**Re: *Addendum No. 1***  
***2023 Asphalt Pavement Program***  
***Village of Hartville***

Date: February 21, 2023

In Section 9, **Replace** drawing sheets Exhibit 1 to 5 with the enclosed sheets Exhibit 1A to 5A.

**EXHIBIT 1A**  
**2023 PAVING PROGRAM**  
**VILLAGE OF HARTVILLE, OHIO**

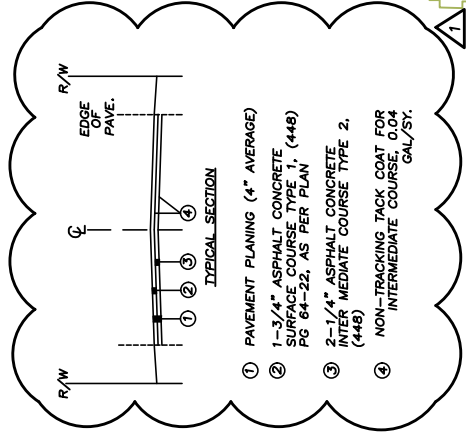
- REVISED TO REMOVE PAVEMENT FABRIC.
- REVISED TO REMOVE NON TRACKING TACK COAT, 0.075 GAL/SY

## EXHIBIT 2A 2023 PAVING PROGRAM VILLAGE OF HARTVILLE, OHIO

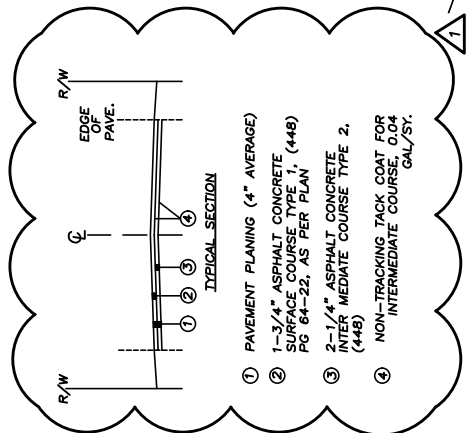
REVISION NO. 1  
 • REVISED TO REMOVE PAVEMENT FABRIC.  
 • REVISED TO REMOVE NON TRACKING TACK COAT, 0.075 GAL/SY

## EXHIBIT 3A 2023 PAVING PROGRAM VILLAGE OF HARTVILLE, OHIO

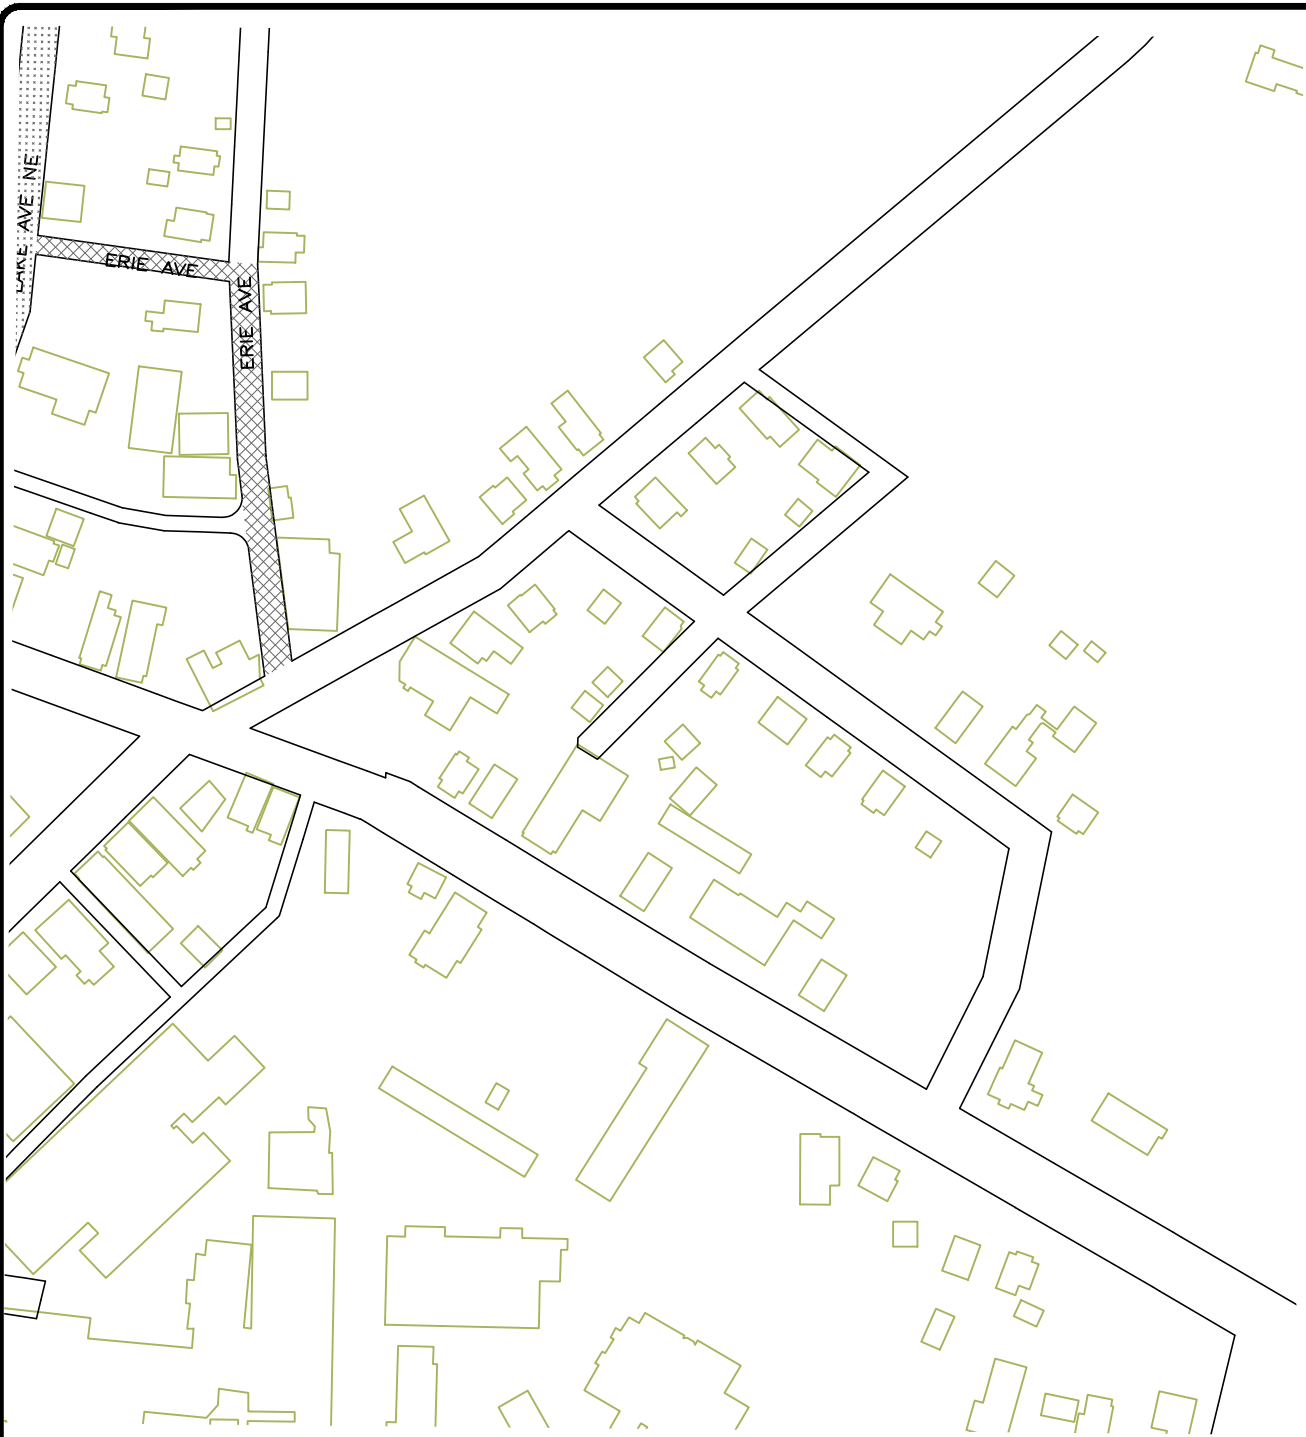
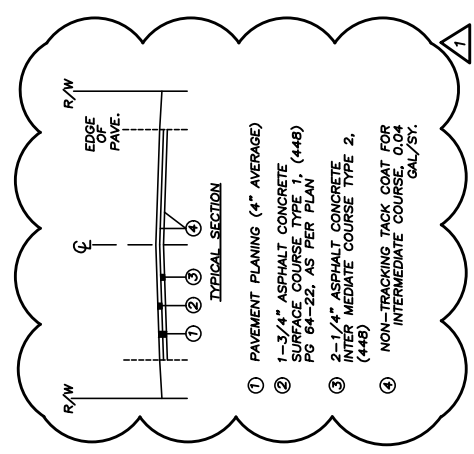
- REVISED TO REMOVE PAVEMENT FABRIC.
- REVISED TO REMOVE NON TRACKING TACK COAT, 0.075 GAL/SY

**EXHIBIT 4A**  
**2023 PAVING PROGRAM**  
**VILLAGE OF HARTVILLE, OHIO**

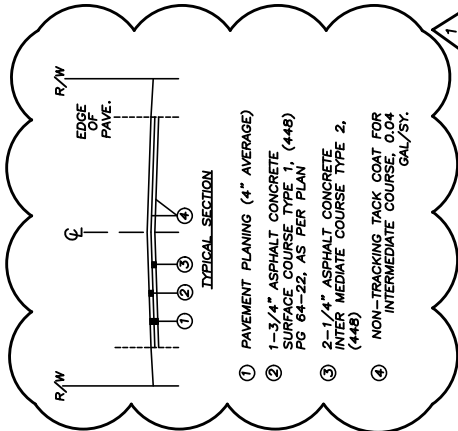
- REVISED TO REMOVE PAVEMENT FABRIC.
- REVISED TO REMOVE NON TRACKING TACK COAT, 0.075 GAL/SY

**EXHIBIT 5A**  
**2023 PAVING PROGRAM**  
**VILLAGE OF HARTVILLE, OHIO**

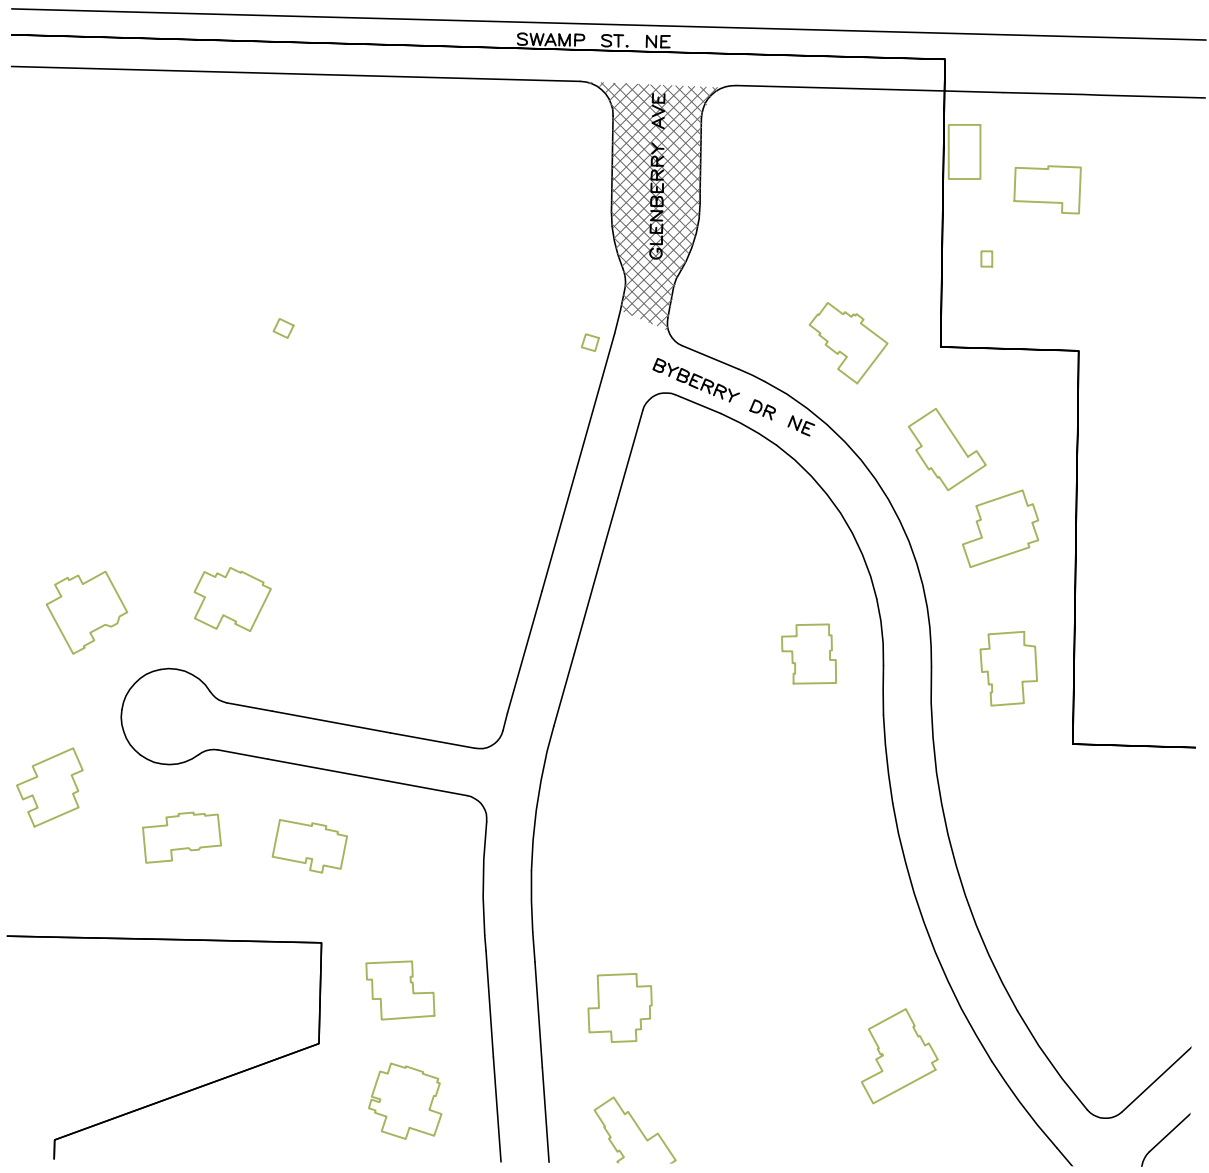
- REVISED TO REMOVE PAVEMENT FABRIC.
- REVISED TO REMOVE NON TRACKING TACK COAT, 0.075 GAL/SY

- ① PAVEMENT PLANING (4" AVERAGE)
- ② 1-3/4" ASPHALT CONCRETE SURFACE COURSE PER PG 64-22, AS PER PLAN (448)
- ③ 2-1/4" ASPHALT CONCRETE INTERMEDIATE COURSE TYPE 2, (448)
- ④ NON-TRACKING TACK COAT FOR INTERMEDIATE COURSE, 0.04 GAL/SY.
